**Subject: 3<sup>rd</sup> MHI's Response to US-APWR DCD RAI No. 719-5352 Revision 0 (SRP 15.06.05)**

3<sup>rd</sup> MHI's Response to US-APWR DCD RAI No. 719-5352 Revision 0

**RAI NO.:** NO. 719-5352 REVISION 0

**SRP SECTION:** 15.06.05 – LOSS OF COOLANT ACCIDENTS RESULTING FROM SPECTRUM OF POSTULATED PIPING BREAKS WITHIN THE REACTOR COOLANT PRESSURE BOUNDARY

Figure-1 Boric Acid Solubility Limit vs. Solution Temperature

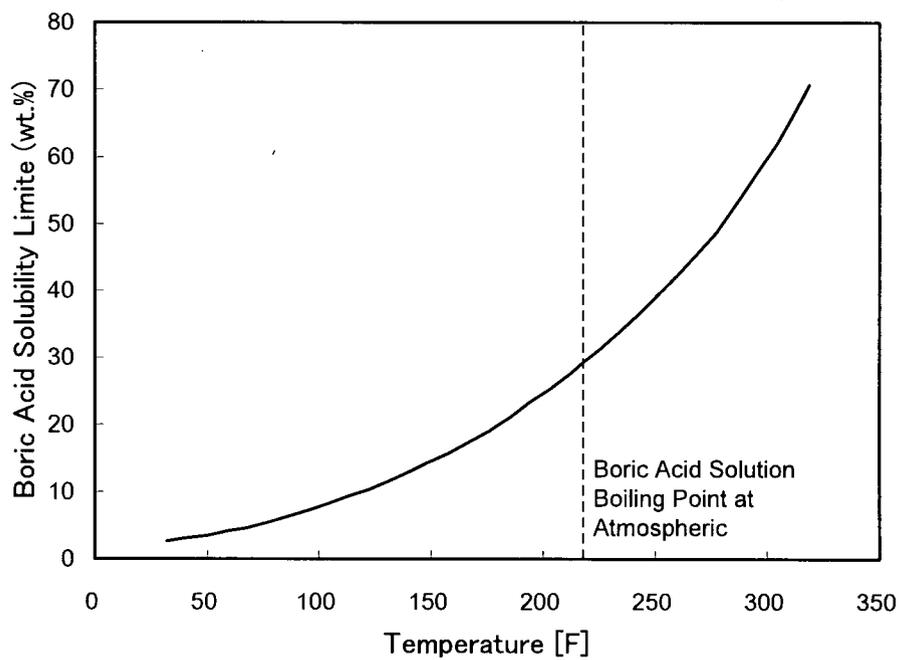
Provide a calculation for the boric acid solubility limit at a solution temperature that conservatively bounds expected coolant temperature variations in the reactor vessel lower plenum during post-LOCA long term cooling. Provide a plot showing the determined precipitation limit as a function of time after the LOCA initiation. Provide relevant data and/or equations used to compute the result as well as those used to compute any other boric acid precipitation limits applied in the US-APWR precipitation analysis. List all assumptions made in calculating the precipitation limits and discuss the impact of each individual assumption on the limiting concentrations obtained. If a parameter that changes in time is represented by a single value, explain how this value was computed and the point in time or time period for which it is representative of. Also, if a volume average quantity is used to represent the conditions in a certain region modeled by a control volume, explain how the spatial distribution effects associated with this parameter have been accounted for in obtaining the volume average value. In considering possible effects related to time and space variations, show that the results applied led to conservative predictions.

The temperature dependency of boric acid saturation concentration presented in reference-(1) is

shown in Figure-1.

Figure-1 Boric acid Concentration during post-LOCA Long-term Cooling

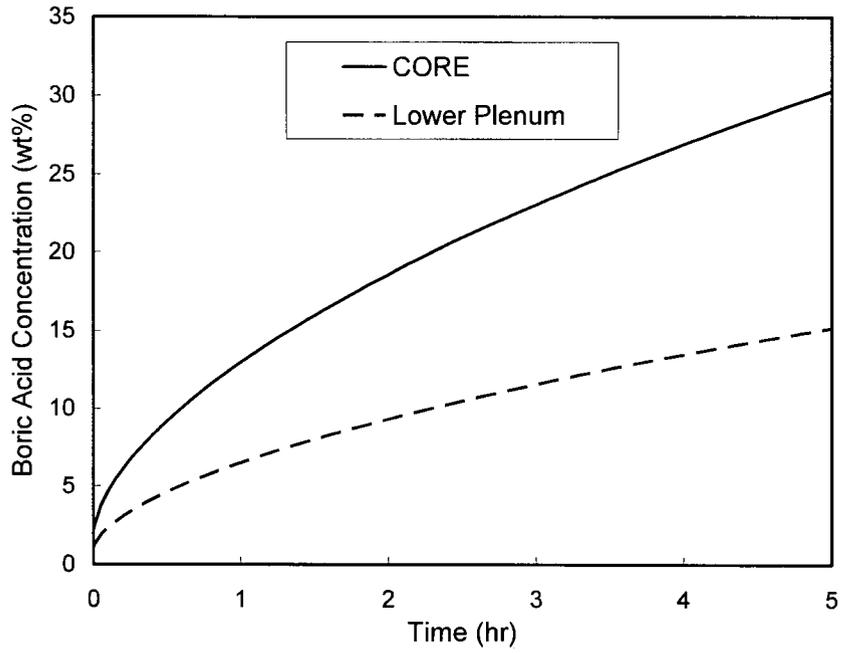
Fibrous debris, in combination with other types of debris, can bypass the US-APWR sump strainer and reach the reactor core region where fuel blockage can take place. Debris can cause fuel blockage near the reactor core inlet region in a direct vessel ECCS injection mode and, in a simultaneous ECCS injection mode, fuel blockage in the top core regions becomes possible. Discuss effects from fuel blockage by debris in the reactor coolant on the US-APWR boric acid precipitation evaluation. If fluid mixing between the reactor lower plenum and adjacent core regions has been credited in the precipitation analysis, demonstrate that fuel blockage at the core inlet will not preclude or adversely impact coolant mixing between the lower plenum and the core. In addition, show that fuel blockage by debris in the top core area will not interfere with downwards coolant penetration into the core region during the core flushing process.

The calculated time-history of the boric acid concentration is presented in Figure-1 which is the same as presented in DCD Figure 15.6.5-42. Figure-1 (dashed line) also shows the lower plenum boric acid concentration based on the assumption of (eq-1).
